**RE:** 1024 Thunderbird Drive  
Fairlane Farms, Lot 40

The OSDS Plan for 1024 Thunderbird Drive has been reviewed with the following comments:

SEPTIC SYSTEM  
INSTALLATION SITE PLAN

1024 THUNDERBIRD DRIVE

PLAN

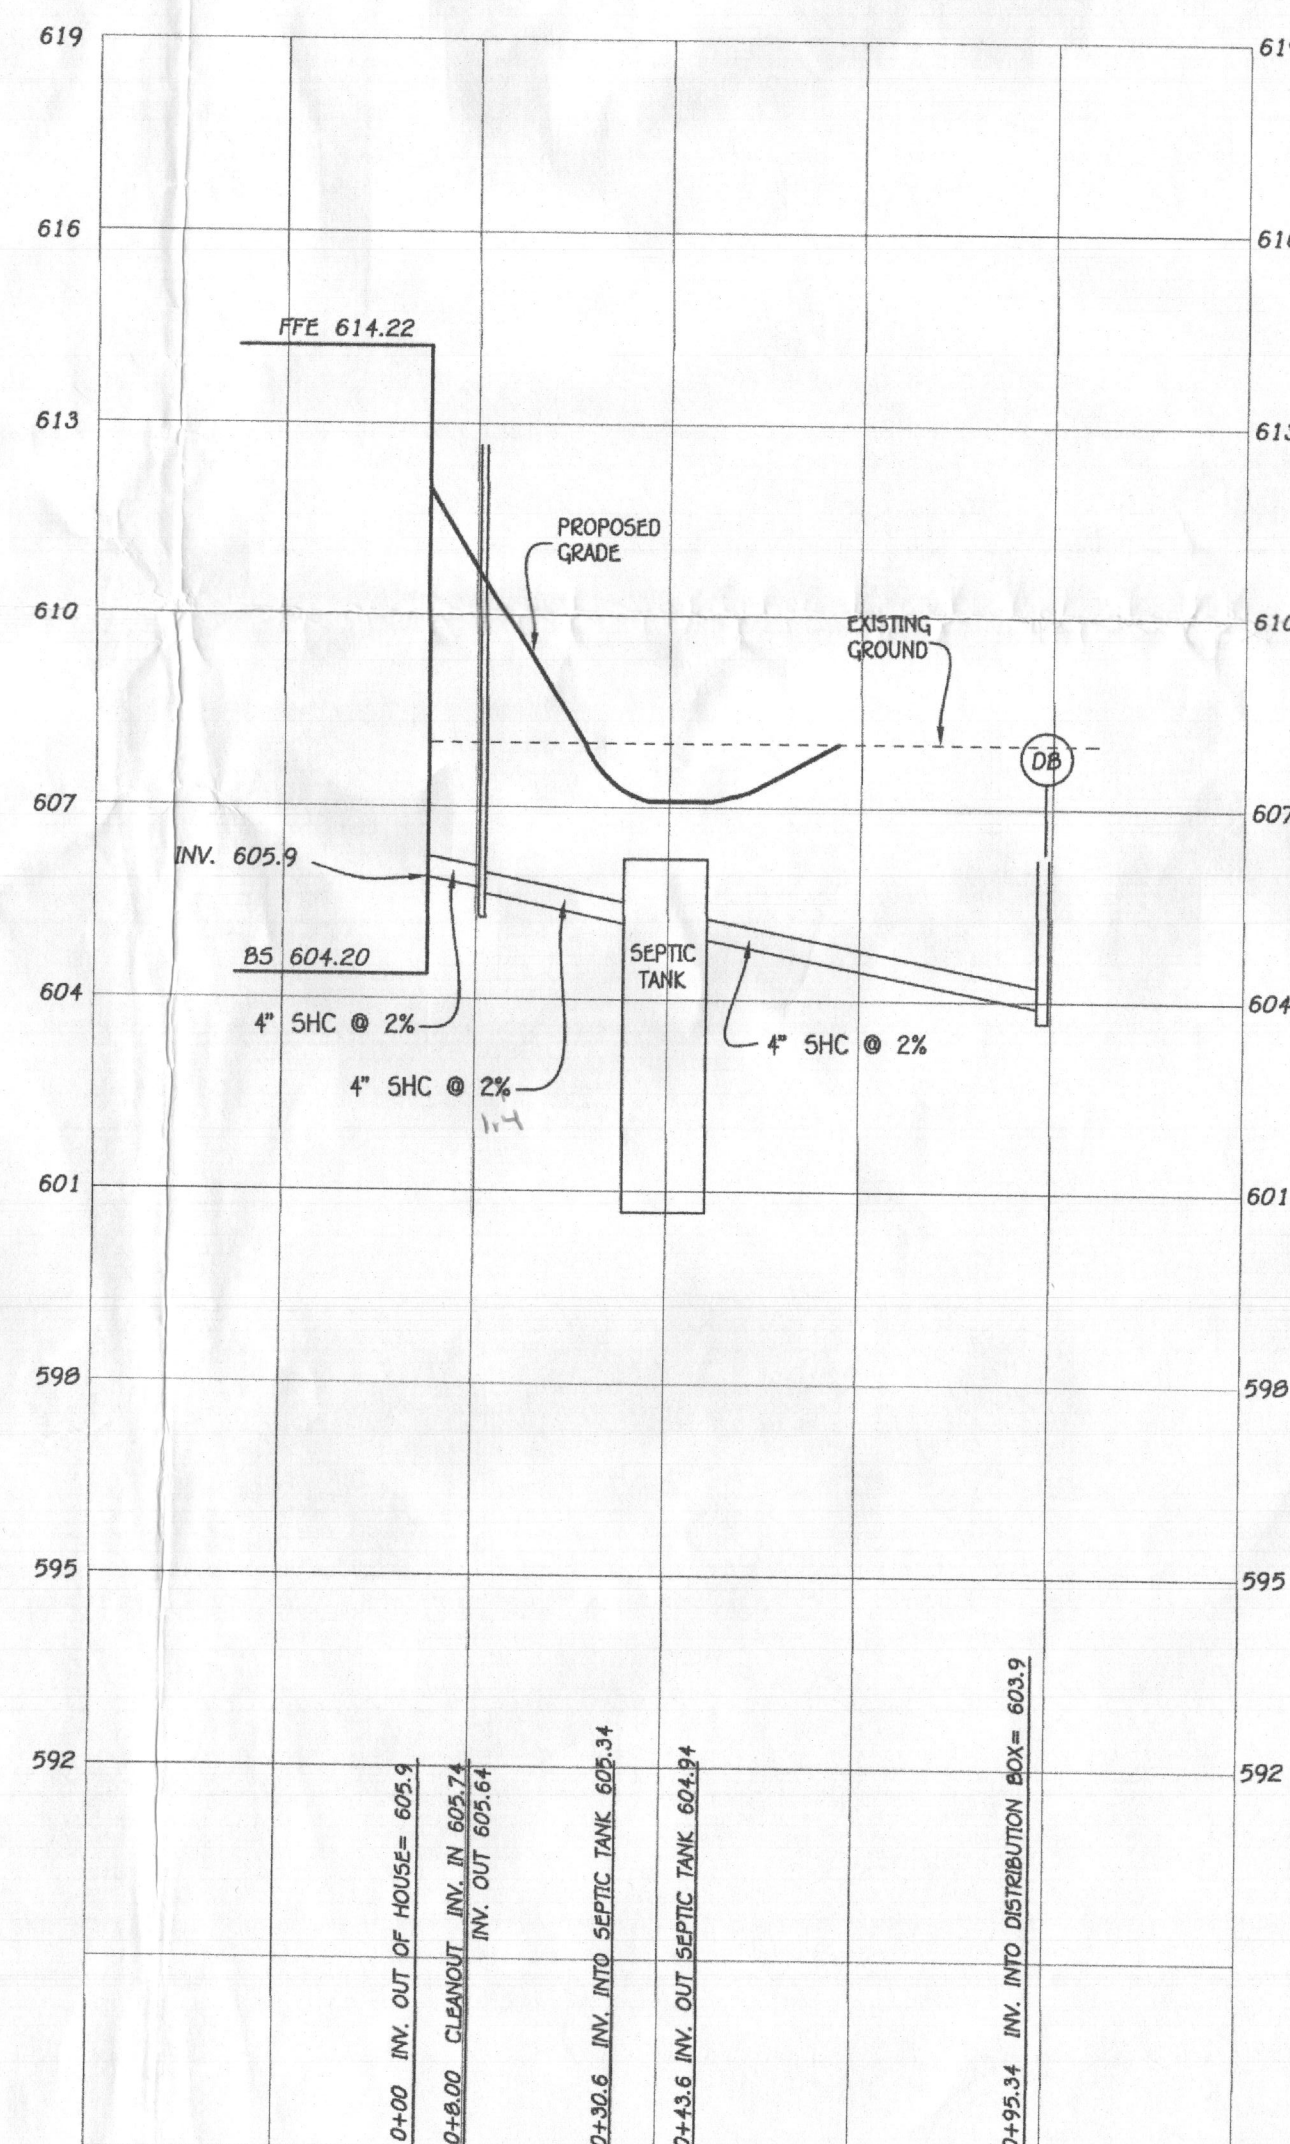
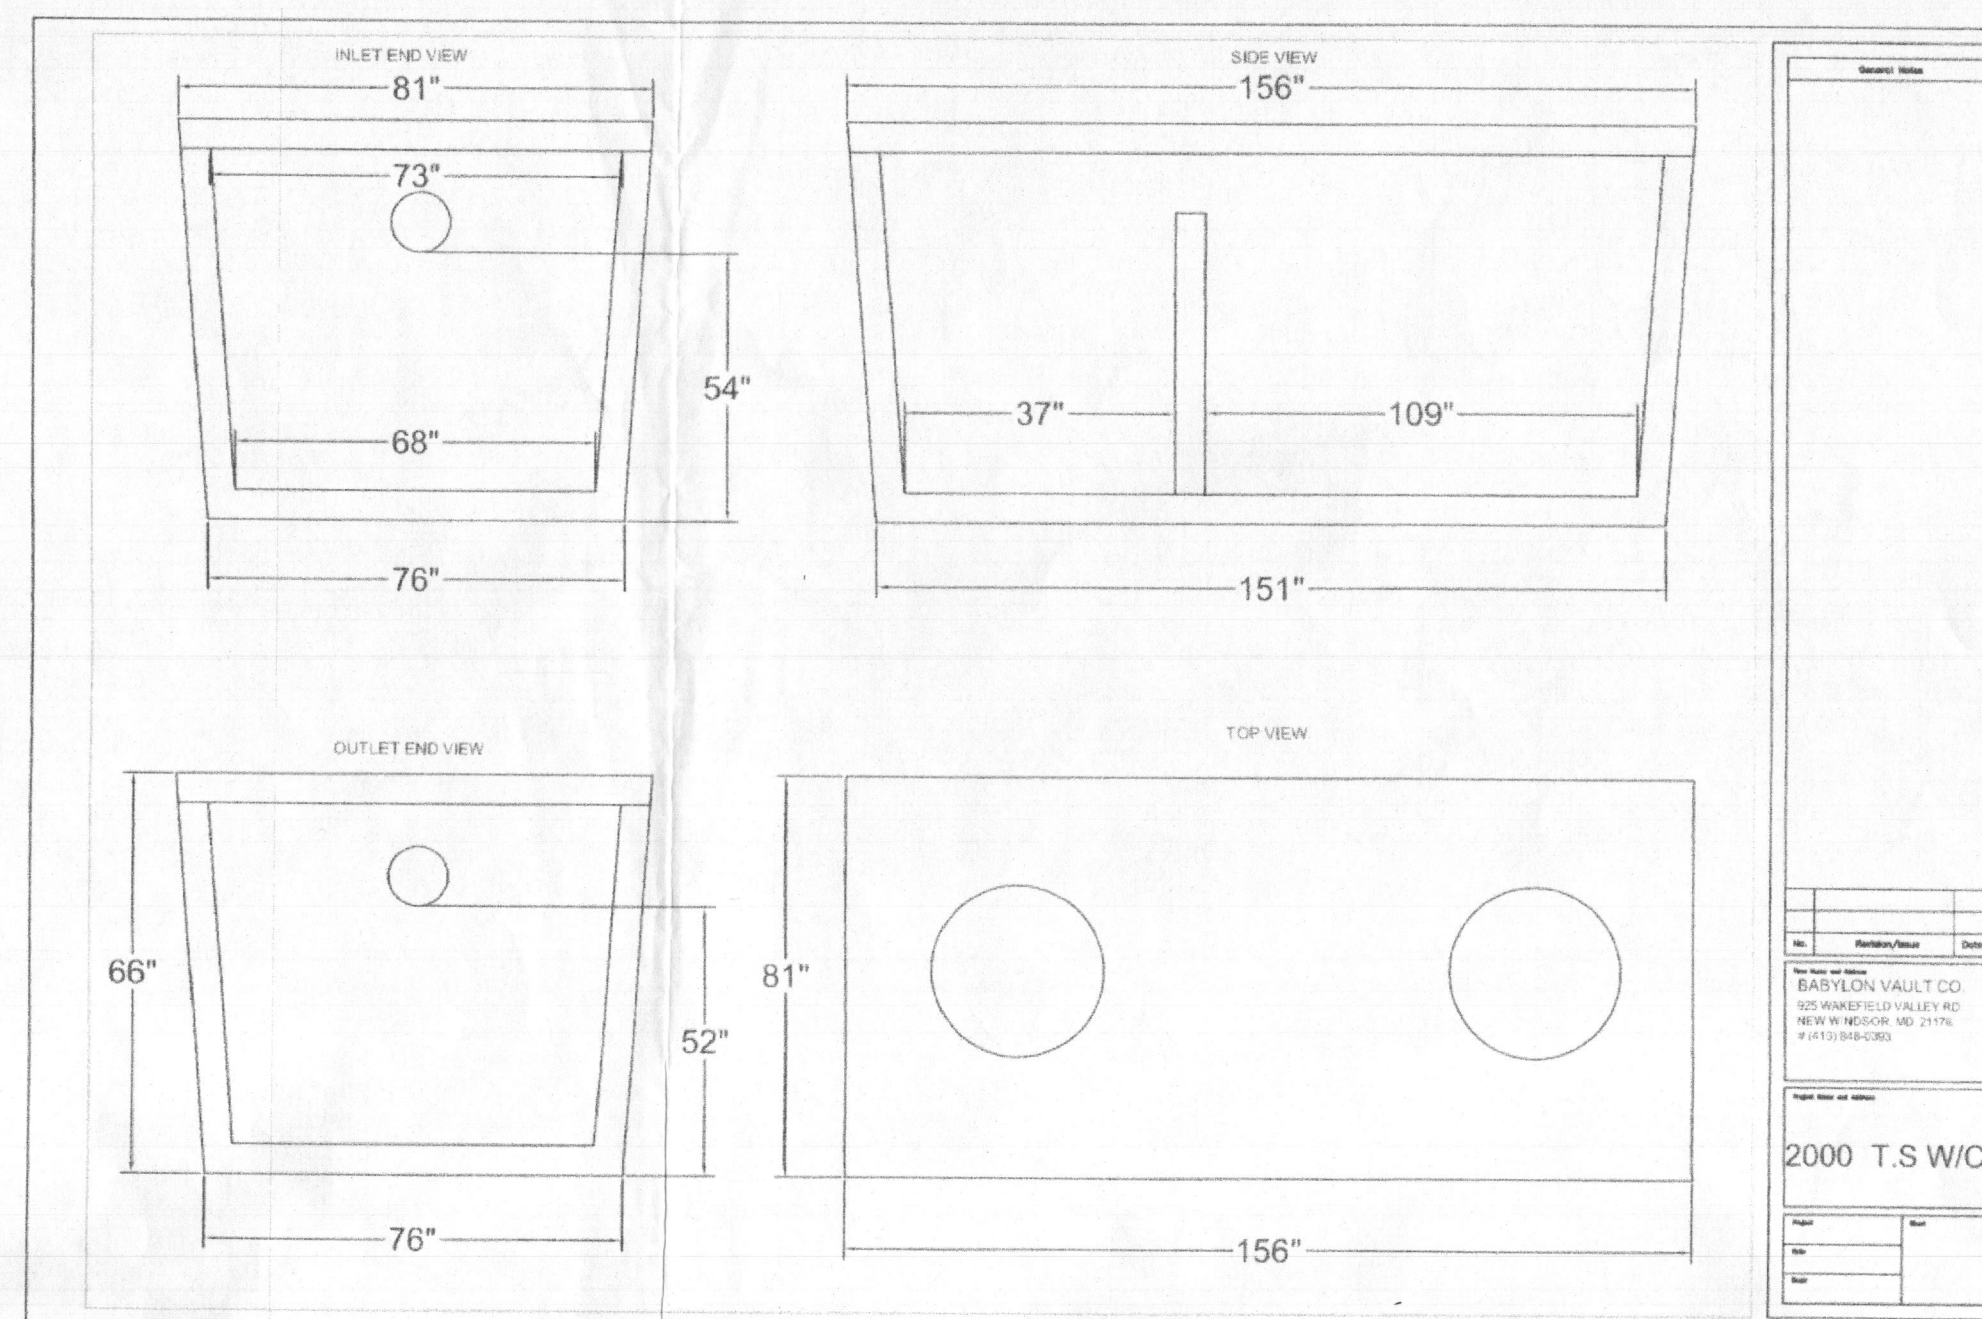
8/29/18 Met S. Carroll on site for layout. Tank + SDA corners staked. Shot contours - differs slightly than shown on plan. Trench ends closest to the house are closer, shapes of trenches are different. Laid out 2 x 44' trenches at highest part of SDA. Keep D-box closer to house to avoid laying pipe over perc hole. (SC)

- 1.) Application rates are incorrect. Should be 1.2 not 0.8. Please review septic specs and make changes to calculations as necessary.
- 2.) Initial trench detail and trench elevations are incorrect (i.e. bottom trench elevation 603.8?)
- 3.) Septic profile elevations do not match adjacent list of elevations
- 4.) Move d-box to center and split trenches. Adjust trench lengths according to new calculations.
